GRADING AND EROSION CONTROL PLANS

SPRINGS AT WATERVIEW

EL PASO COUNTY, STATE OF COLORADO

PCD File No. SF-16-017

PROJECT SPRINGS AT WATERVIEW
 SHEET TITLE 0102.1 - GEC-DETAIL - 3 GENERAL DETAILS
 FROM _____ TO _____
 JOB NO. 0102.1 SHEET --- OF 7

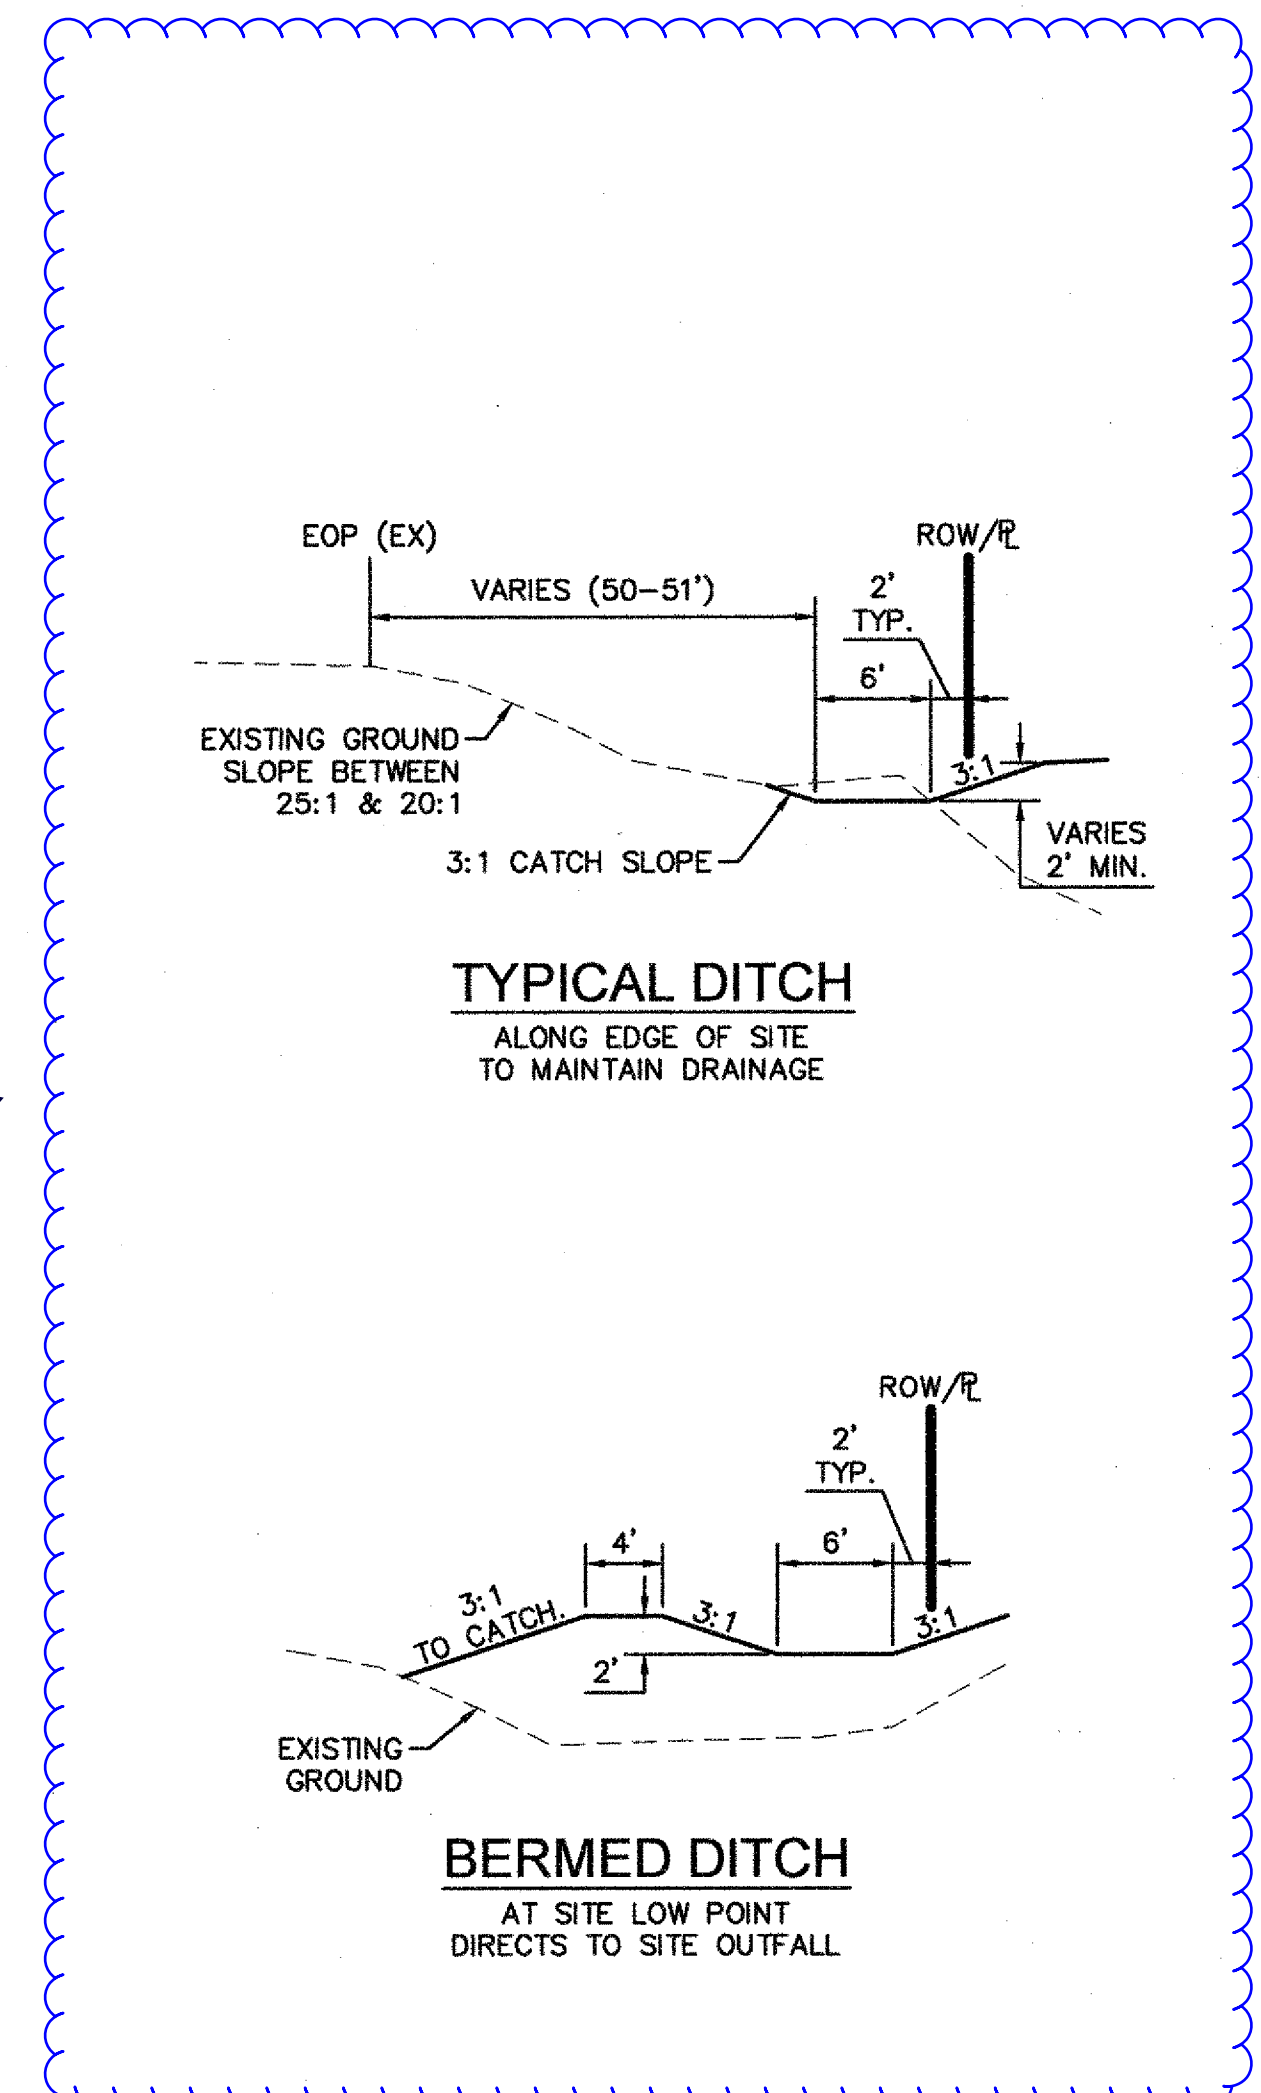
Provide revision cloud to identify any and all changes from the previously approved plan.
Engineer of record to stamp/sign all revised sheets

PROJECT SPRINGS AT WATERVIEW
 SHEET TITLE GRADING & EROSION CONTROL PLAN
 FROM _____ TO _____
 JOB NO. 0102.1 SHEET 5 OF 7

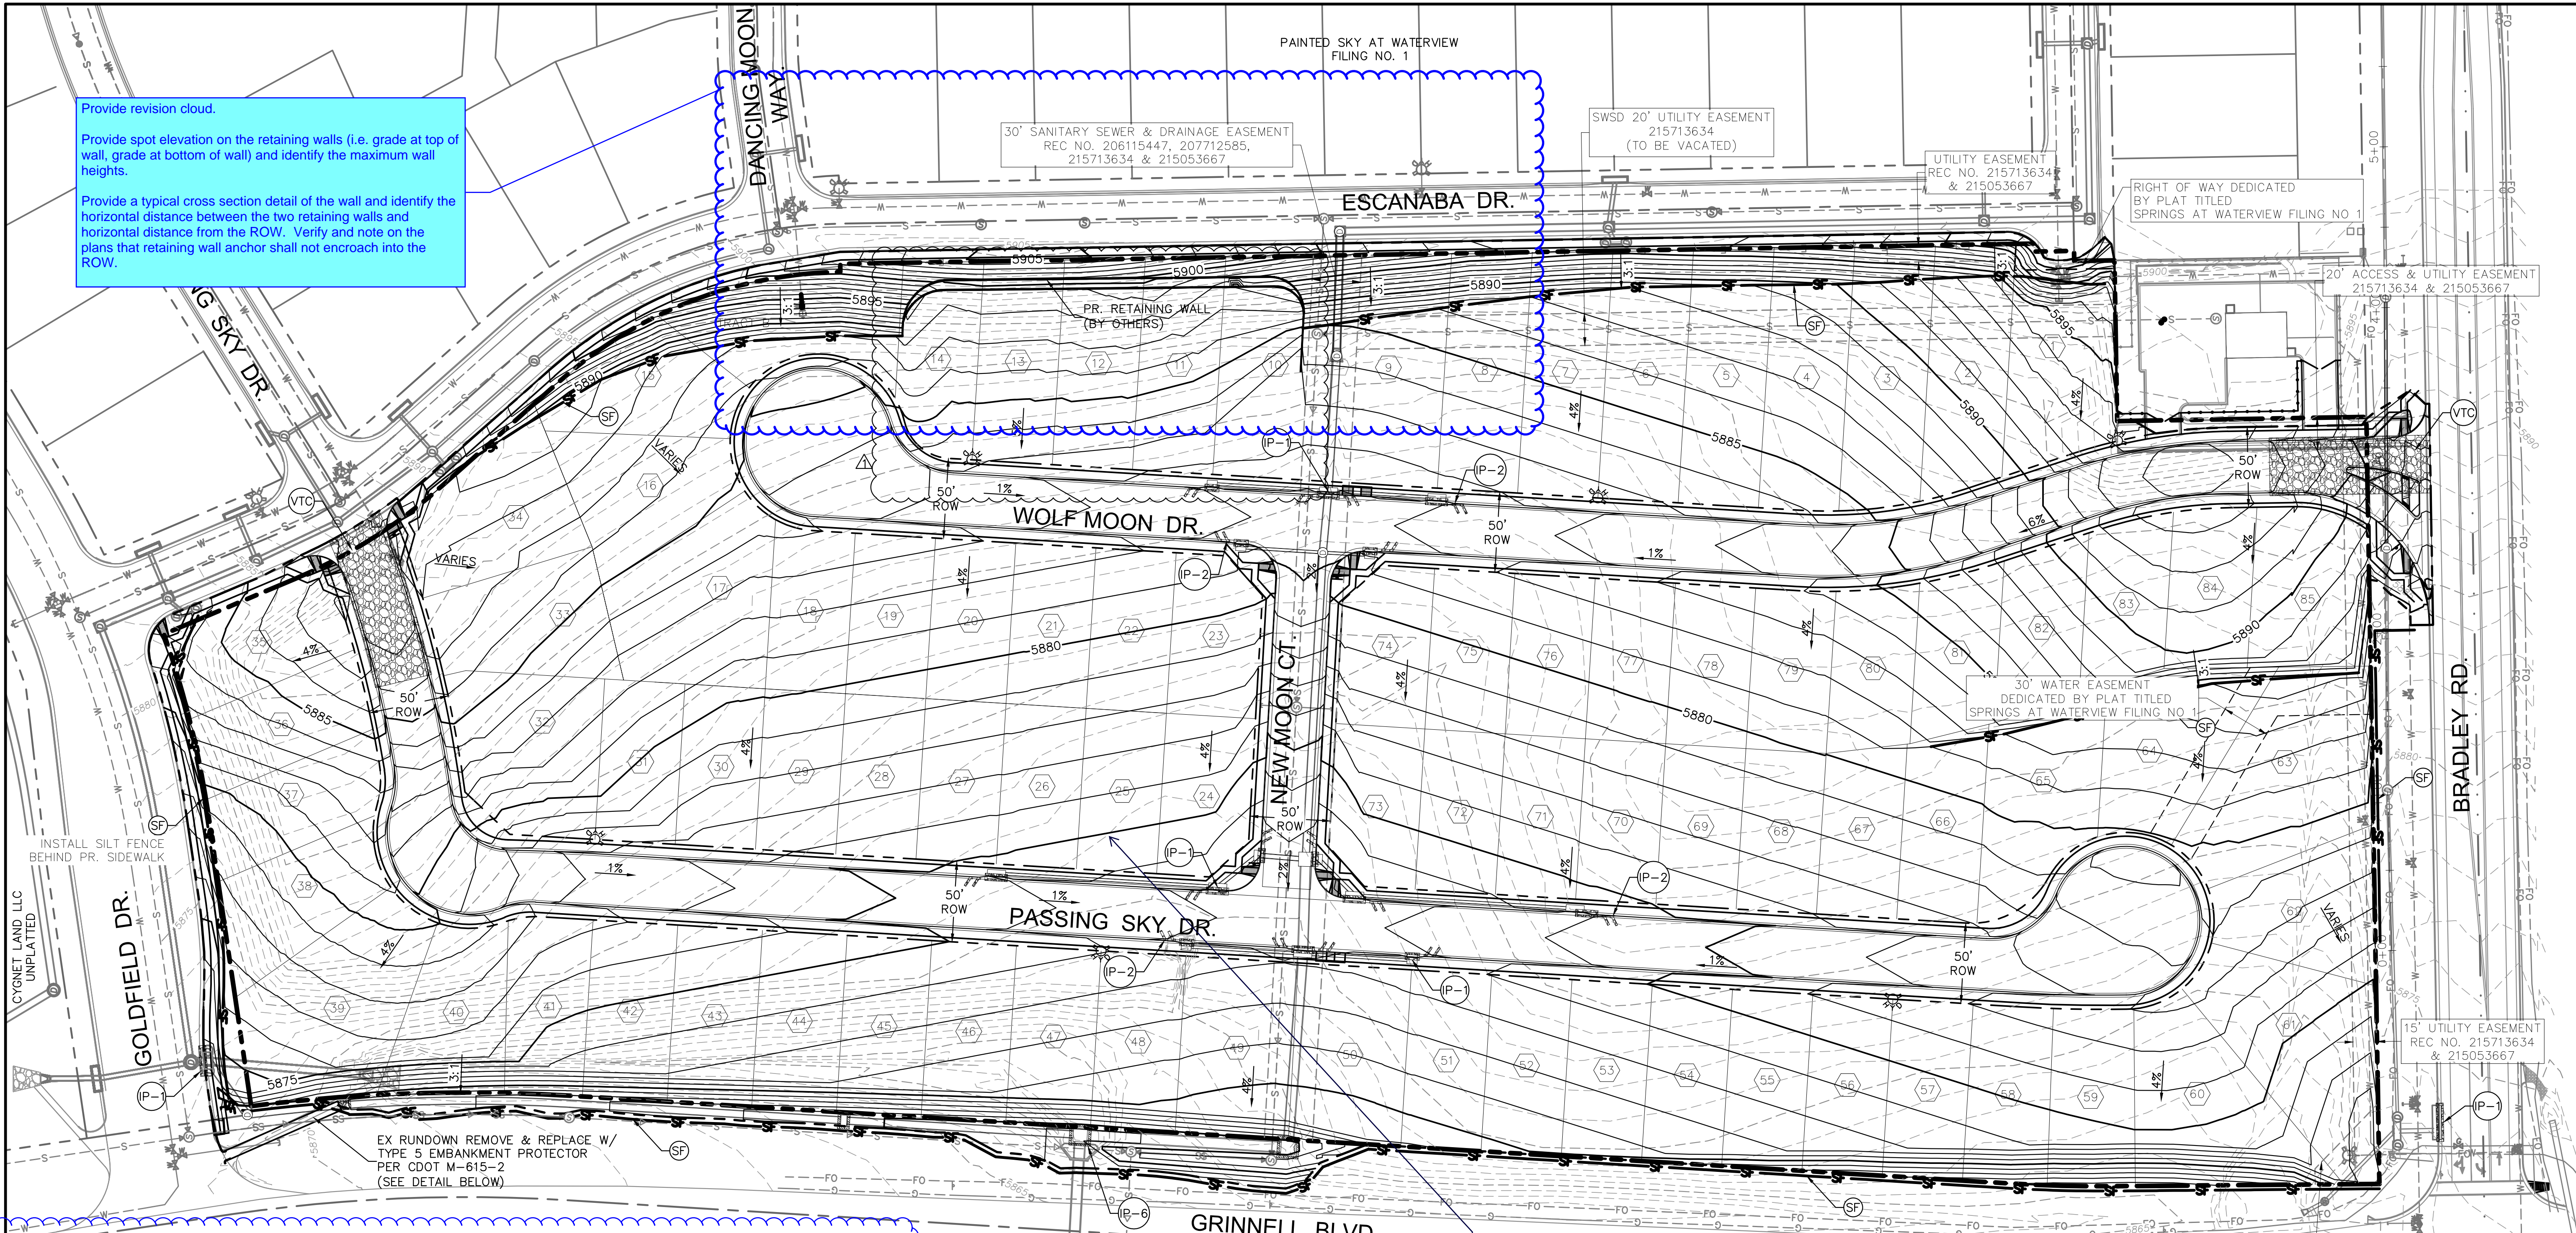
Provide revision cloud.

Provide spot elevation on the retaining walls (i.e. grade at top of wall, grade at bottom of wall) and identify the maximum wall heights.

Provide a typical cross section detail of the wall and identify the horizontal distance between the two retaining walls and horizontal distance from the ROW. Verify and note on the plans that retaining wall anchor shall not encroach into the ROW.

Applicant submitted a second document named "Revised Grading Plan". Unclear why there are two different grading plan showing two different contours throughout the site.

Update this GEC plan contours to reflect the actual proposed design.

Provide riprap calculation in the drainage letter

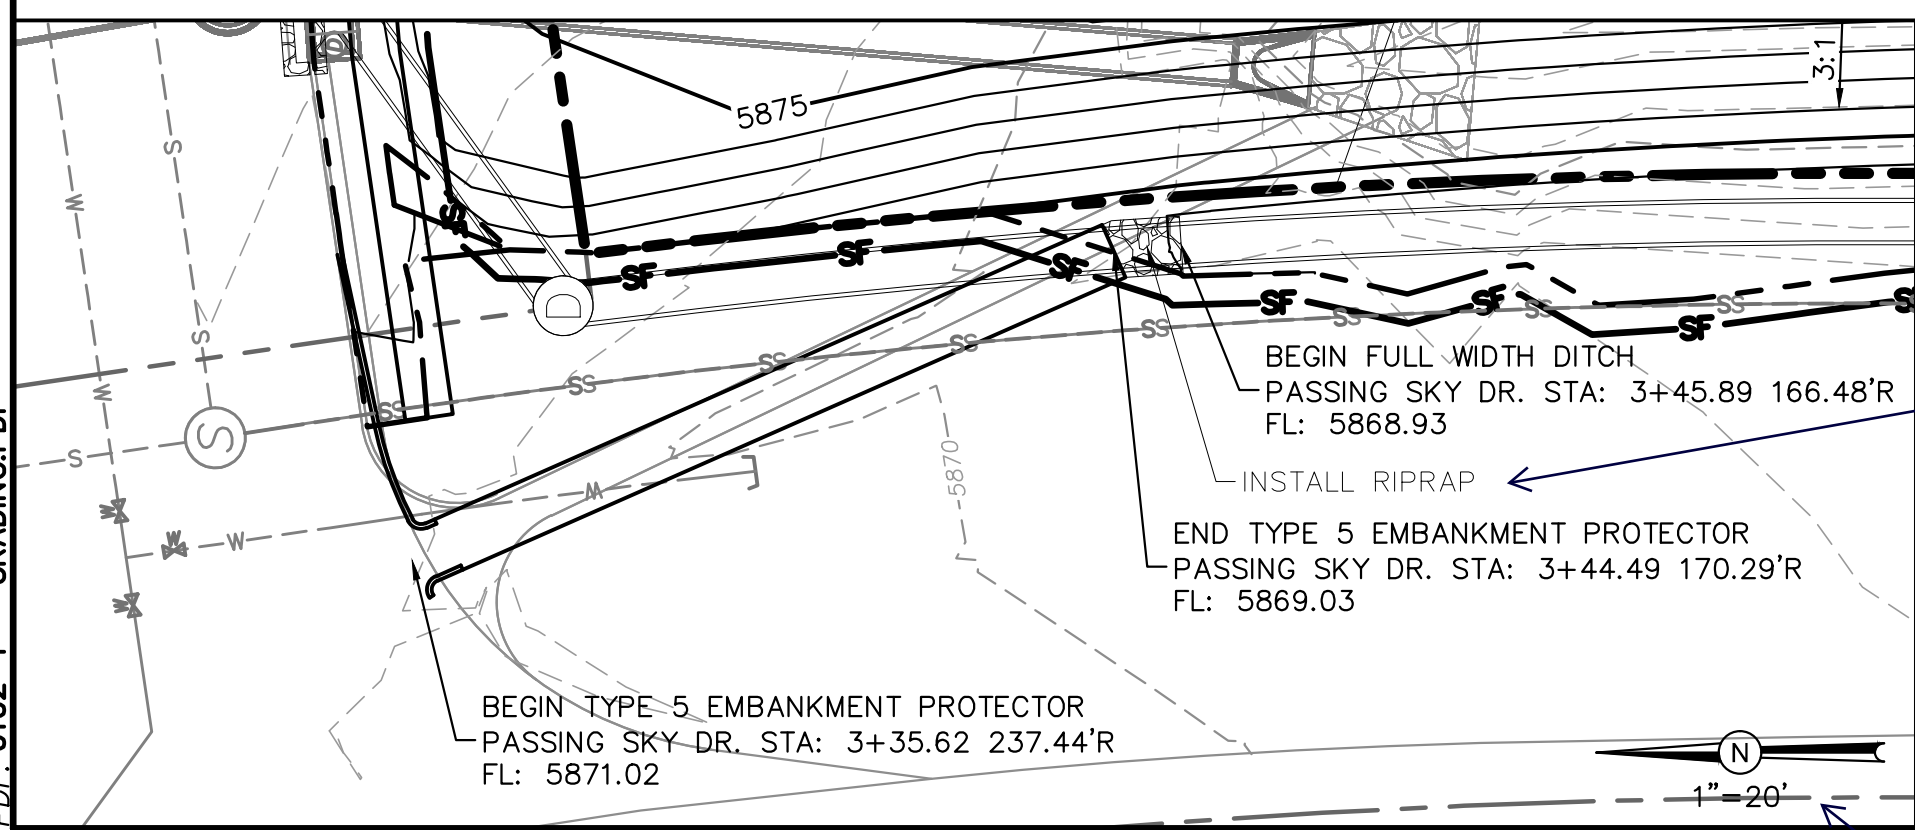
Update callout to identify the LxWxD and the riprap type (L, M, or H)

include bar scale
